Architectural Review Committee

TOWN OF BROOKFIELD ARCHITECTURAL REVIEW COMMITTEE STAFF REPORT

RE: ARC Staff Report – May Agenda Items

Master Spa Warehouse – Preliminary Approval

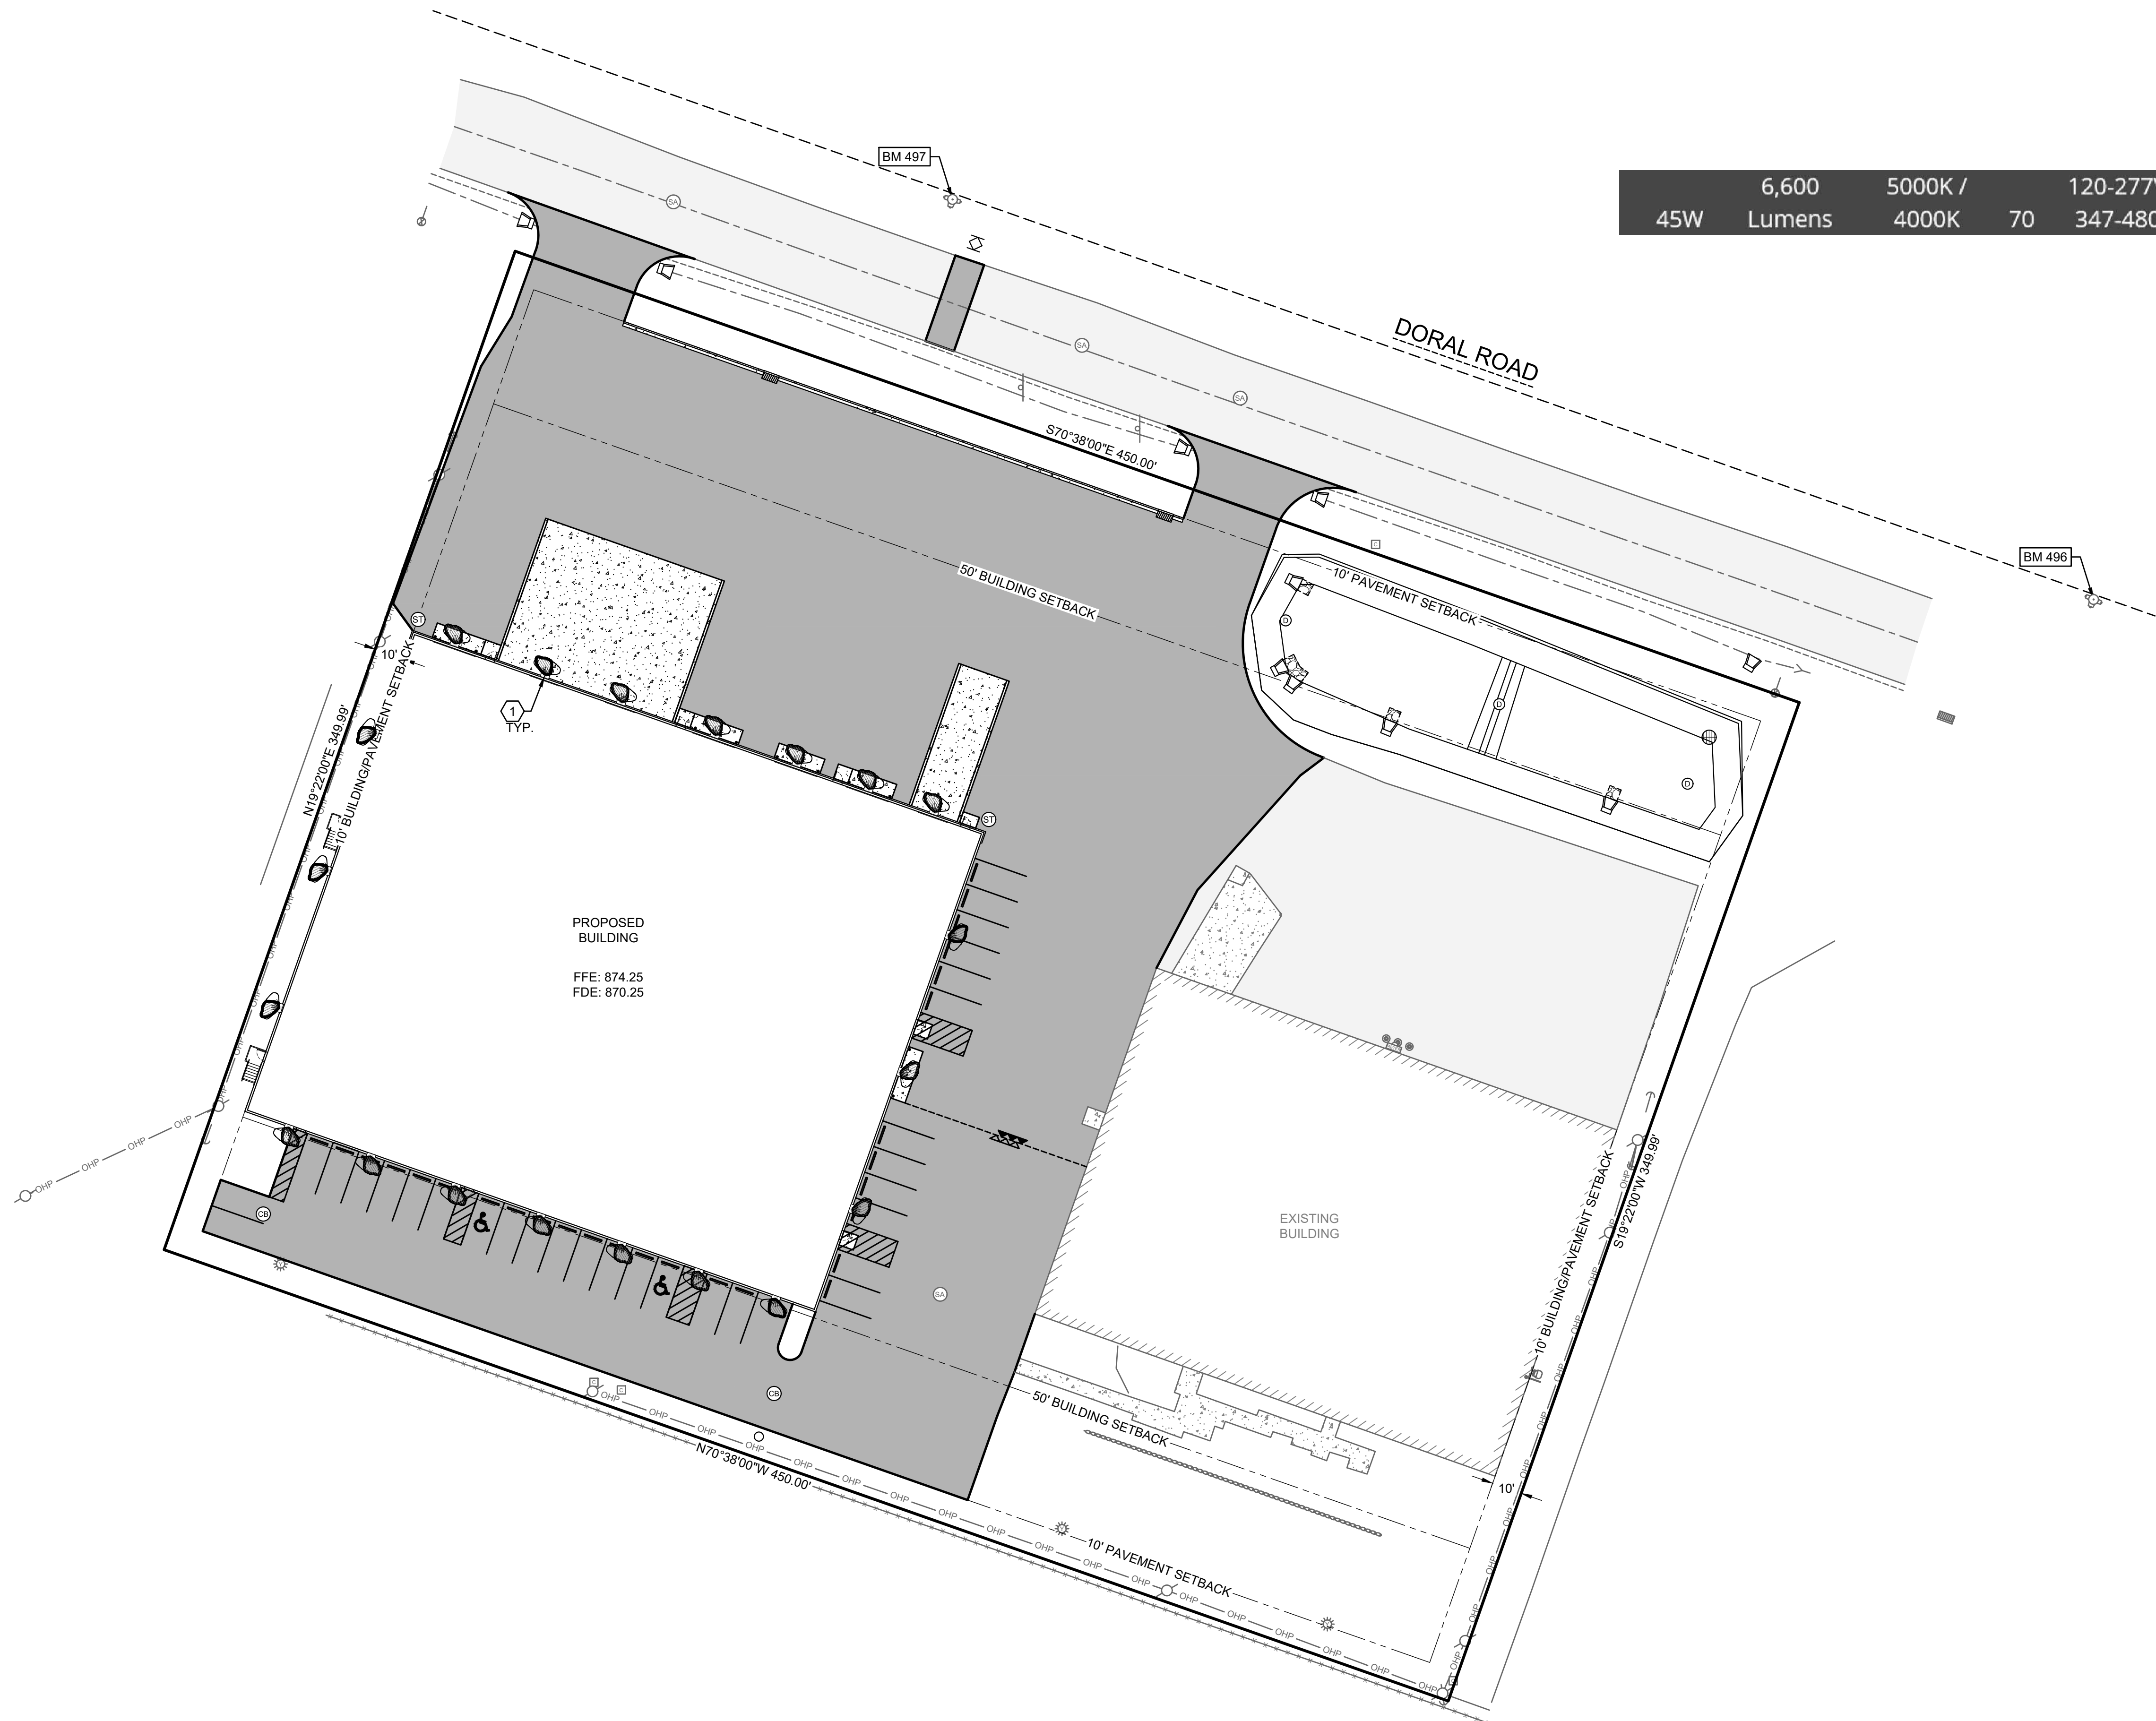
1. A photometric plan, including calculations for the average, minimum and maximum, and uniformity for the parking lot lighting, was reviewed. Photometrics must also be shown at the property lines on all sides. Light level shall not exceed 0.2 footcandles at the property line. A product data sheet for the proposed light fixture should also be submitted.
